Point Beach Nuclear Plant, Units 1 and 2
Dockets 50-266 and 50-301
Renewed License Nos. DPR-24 and DPR-27

License Amendment Request 261, Supplement 4
Extended Power Uprate

LICENSE AMENDMENT REQUEST 261, SUPPLEMENT 4 EXTENDED POWER UPRATE

Case 10-1: 1B-42 MCC Voltage Profile

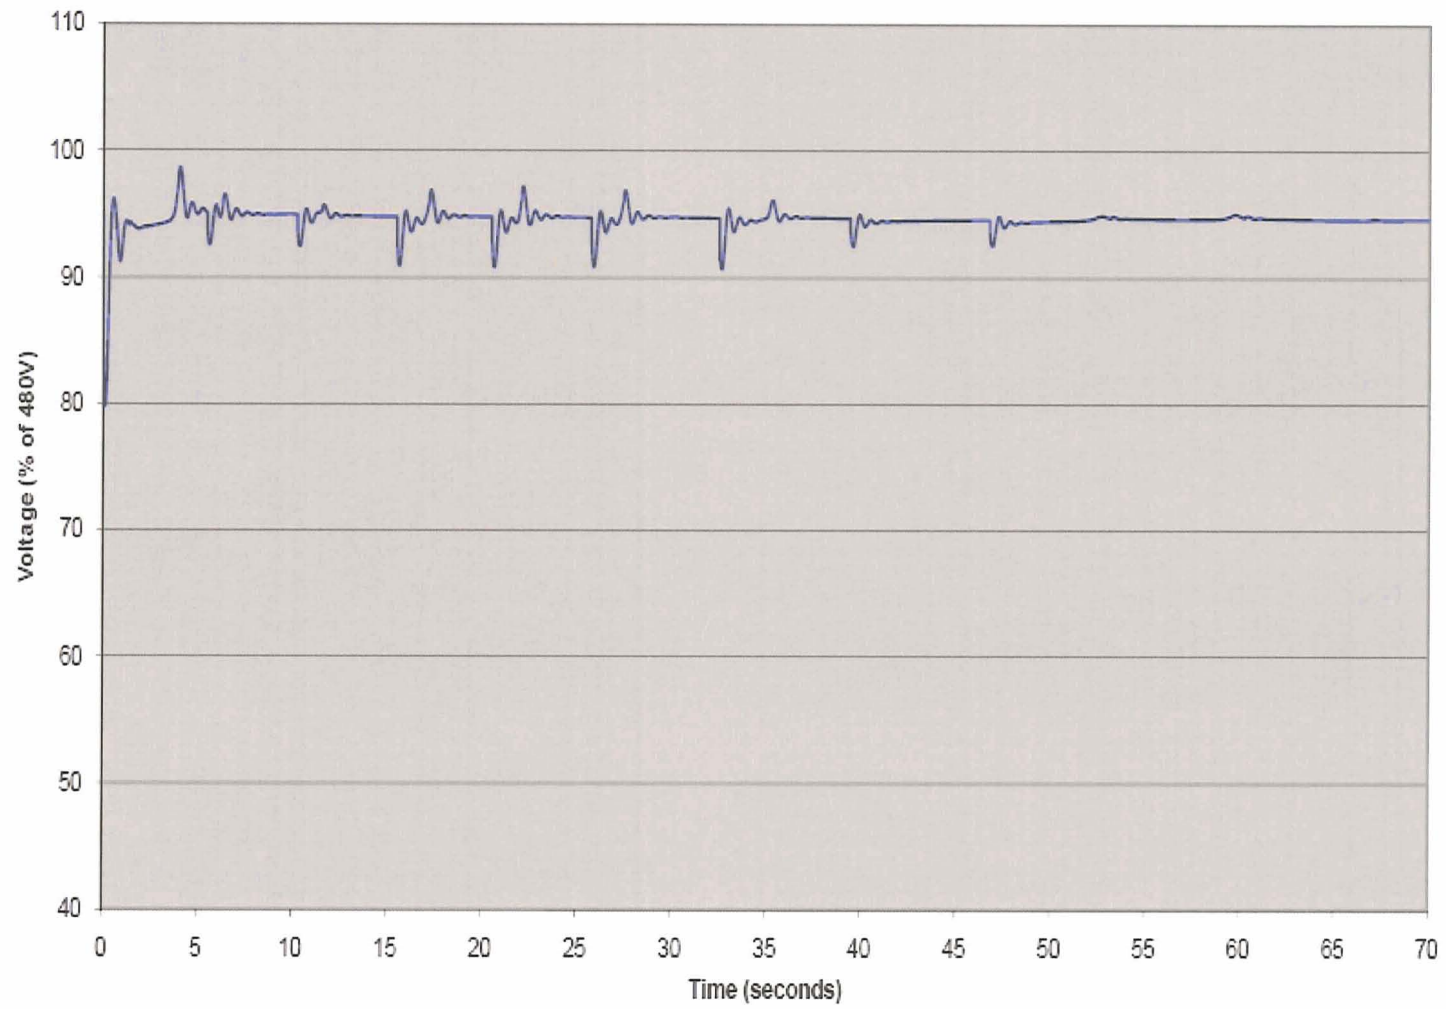
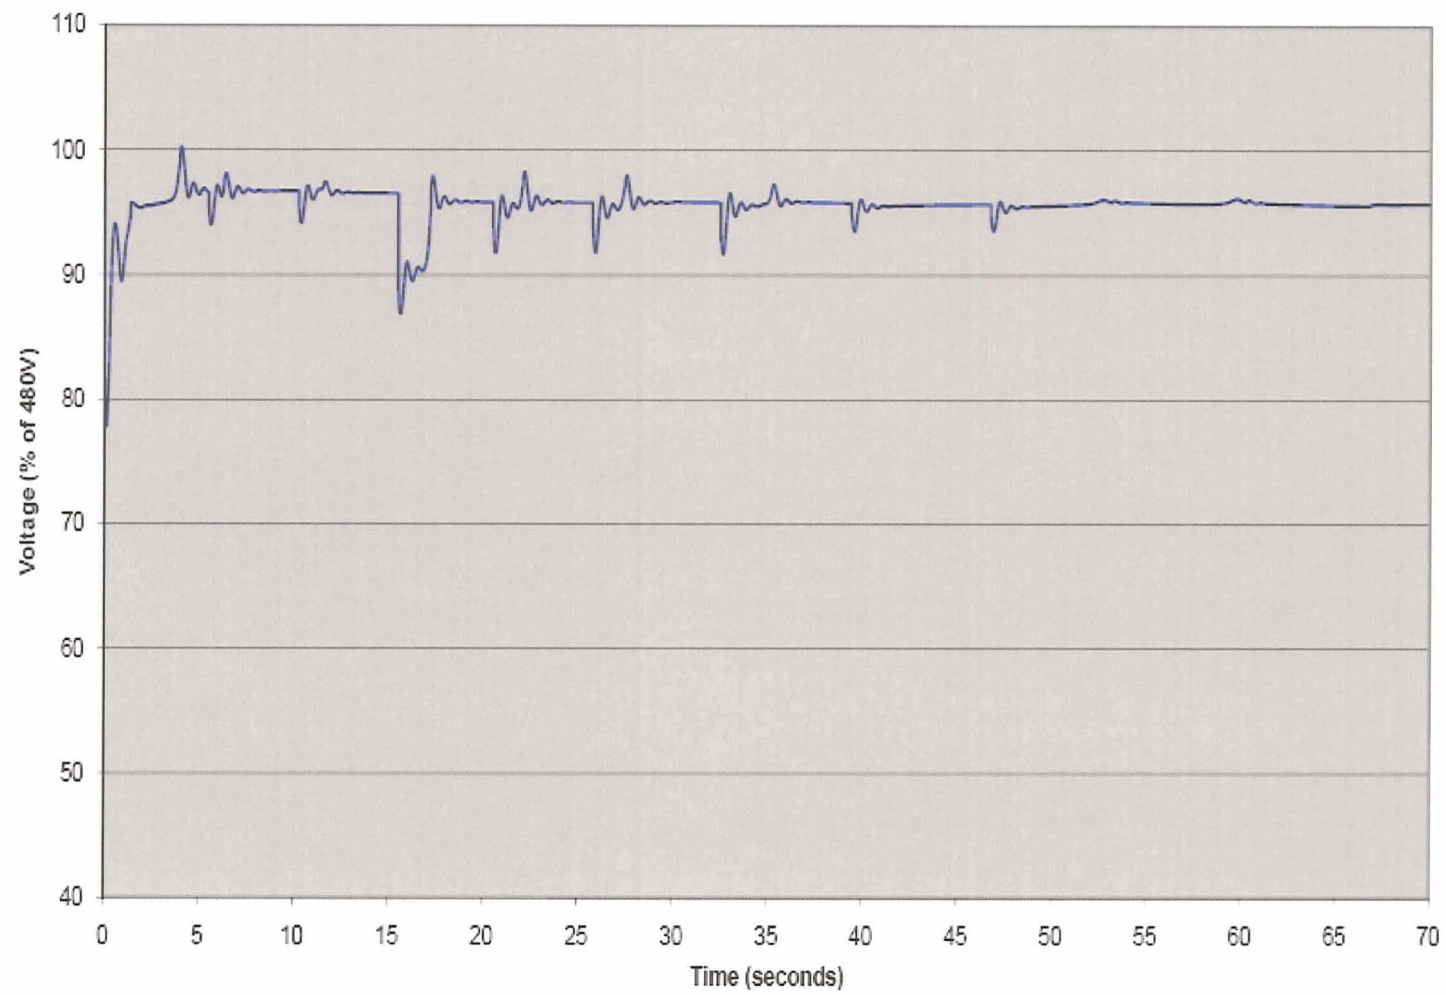
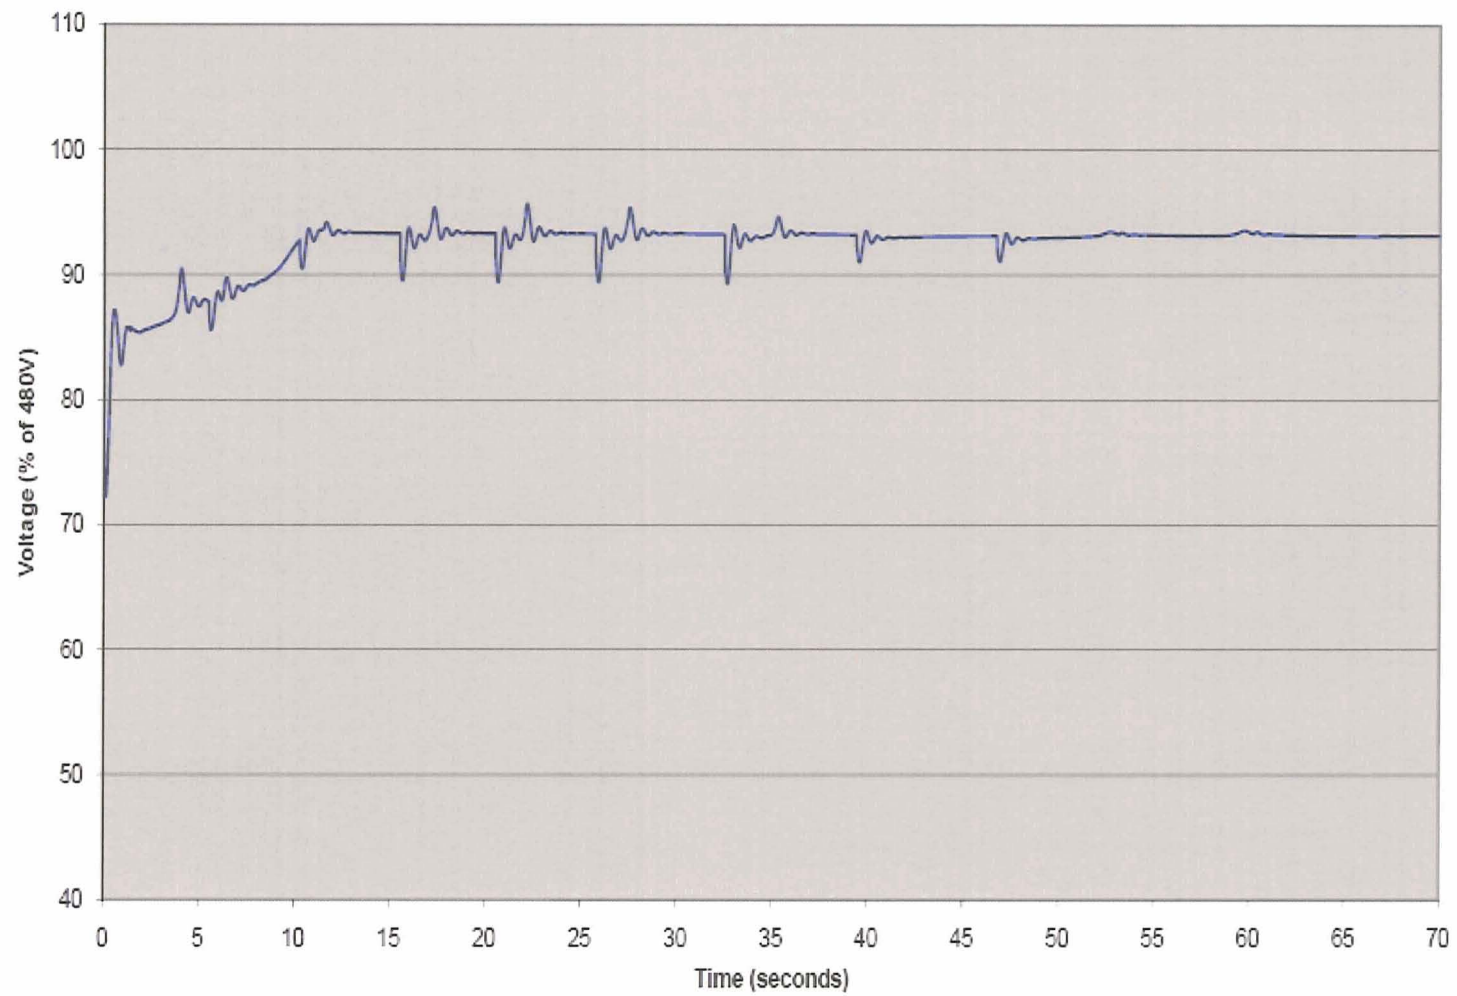
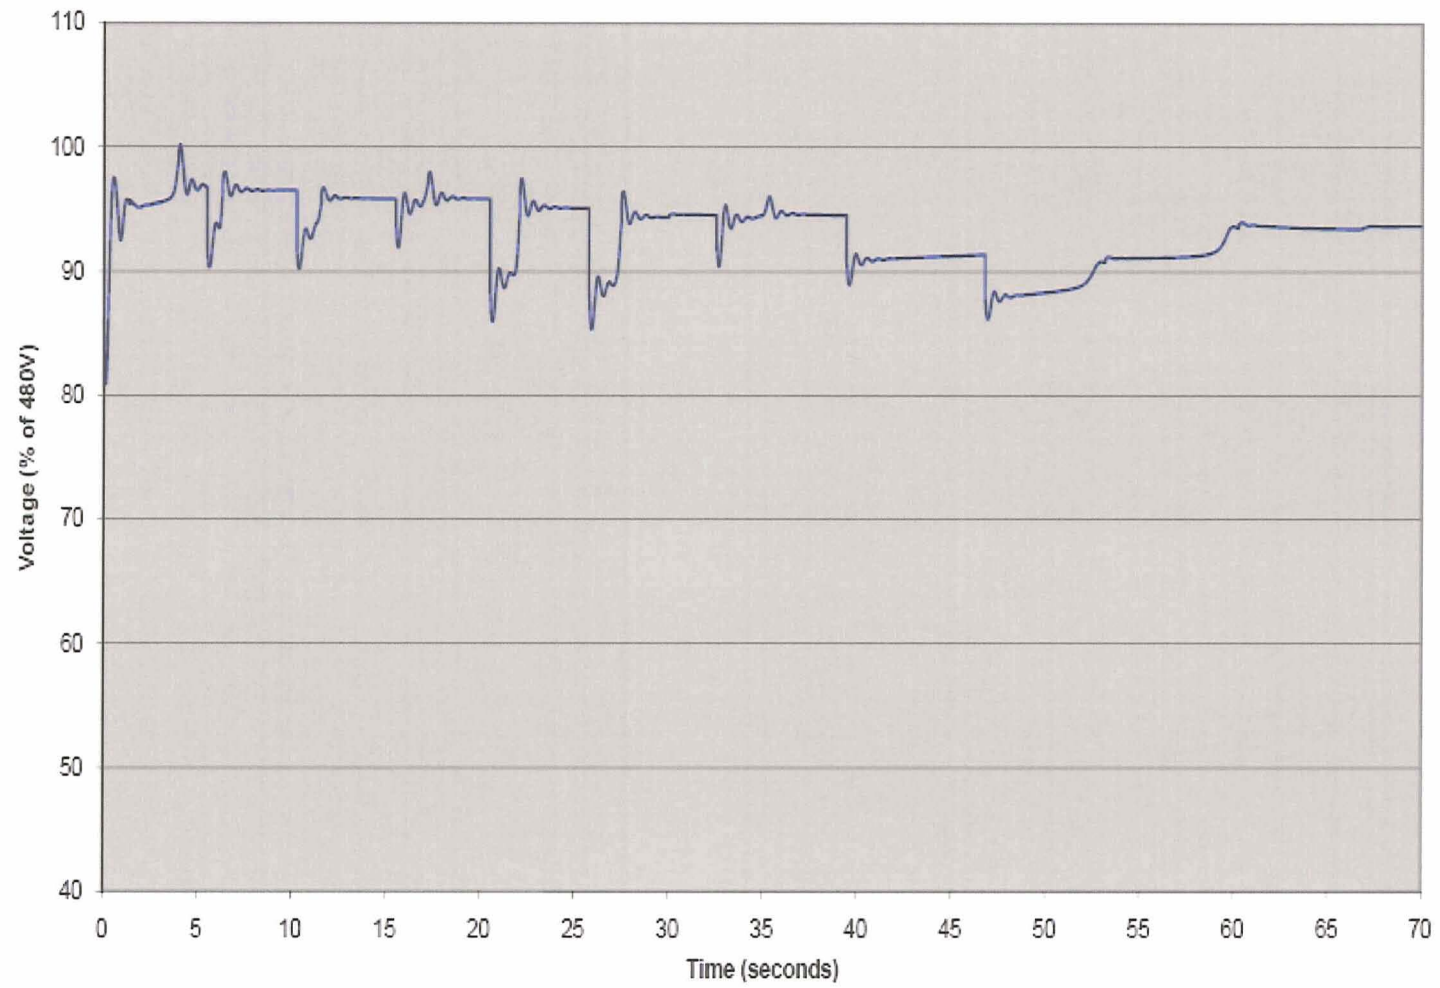
In response to staff's request for additional information (RAI) dated August 26, 2009, regarding the emergency diesel generator (EDG) voltage dip below the acceptance limit of 75 percent nominal voltage during motor start, the licensee stated that the EDGs are capable of starting safeguard loads, and the voltage recovers quickly to the acceptable level. Based on staff's review of the dynamic loading calculations, the staff notes that under certain loading conditions for Train "A" EDG, the frequency is outside 2 percent margin, the worst-case voltage dip is 45-48 percent and the voltage overshoot is 129.5 percent. Train "A" voltage and frequency variations are outside the industry accepted standards and guidance. Provide detailed analyses regarding the downstream effects on components such as contactors, control fuses, inverters, battery chargers, solenoids, motor-operated valves, solid state devices, etc., and the basis to show that all required loads will start and continue to run with sufficient margins after accounting for any uncertainties. Provide justification for the performance capabilities of the EDG "A" regulator and excitation systems to support shutdown equipment within design-basis requirements during a design-basis accident. The staff notes that Train "B" EDG bus voltages remain above 75 percent of nominal voltage, consistent with NRC Regulatory Guide (RG) 1.9, throughout the motor starting sequence in all postulated loading conditions. Provide a summary of all bus voltages for the 'B' train distribution system.

Attachment 5 provides a summary of bus voltages for the "B" train distribution system for the above large break LOCA design basis ETAP cases.
